**NIOSH Comments on the SC&A Review of the Bethlehem Steel Site Profile
Specific Responses to Findings, Observations and Procedural Non-conformances**

January 25, 2005

Figure 1

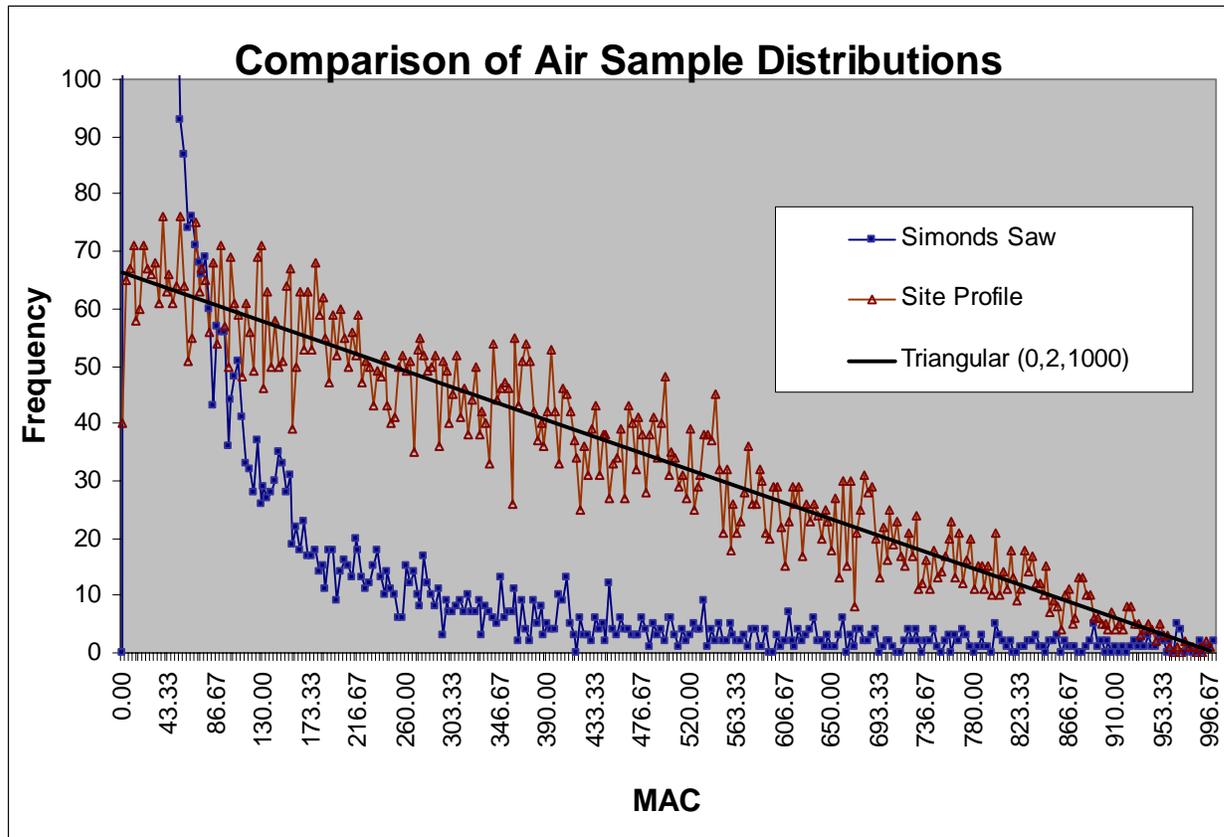
2. The triangular distribution in Table 3 is not a statistically sound representation of the October 27, 1948 Simonds dataset. The upper bound of Table 3 is not claimant-favorable.

NIOSH acknowledges that the triangular distribution used in the site profile does not provide the best statistical fit to the Simonds Saw and Steel dataset. For purposes of making compensation decisions, the triangular distribution was viewed by NIOSH, not as a statistically precise model of the data, but as a claimant favorable characterization of the available log-normal distributions of air sample data at BSC and SSS. The triangular air sample distribution in the site profile was used to construct an internal exposure matrix that could be applied to all four years of covered uranium rolling activities at Bethlehem Steel and Simonds Saw. In doing so, NIOSH attempted to address the uncertainty associated with generating a single distribution based on data from two distinct time periods.

The triangular distribution is more claimant favorable than the underlying log-normal distributions because it results in more frequent selection of values in the extremes of the air sample distribution. Figure 1 provides a comparison of the sampling frequency distribution for the triangular distribution used in the Site profile and the best fit log-normal distribution suggested by SC&A for the Simonds Saw and Steel Data.

As can be seen in Figure 1, the triangular distribution selects a greater number of samples in the upper values of the distribution than the SSS log-normal distribution. NIOSH has rerun a number of cases using the SC&A proposed triangular distribution and found that in all cases the probability of causation was substantially lower (i.e., more than 30%) using SC&A's best fit than that obtained using NIOSH's triangular distribution. This is true, even though the triangular distribution truncates sampling at 1,000 MAC and the 99th percentile of the log-normal distribution was almost 2,500 MAC. This is because the mean value of the probability distribution tends to drive the probability of causation at the 99th percentile. In this case, the mean value of the log-normal distribution proposed by SC&A (168 MAC) is approximately one-half that of the triangular distribution (334).
